# Service Bulletin

Installation of revised shoulder harness restraint.

GA200 all serial numbers  
GA200C aircraft prior to Serial No. 200C-0145.

**Figure 1**

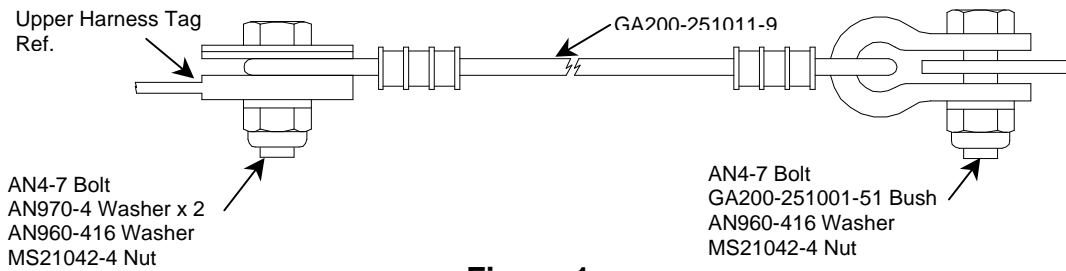
1. Remove existing 1/8" retaining cable from each shoulder harness to aircraft attachment. For aircraft that incorporate a cable that has been swaged integrally with the upper harness yoke it will be necessary to cut the old cable free, ensuring that the harness yoke is not damaged.

2. Install new 5/32" retaining cable P/N GA200-251011-9 using attaching parts as shown in Figure 1 below.
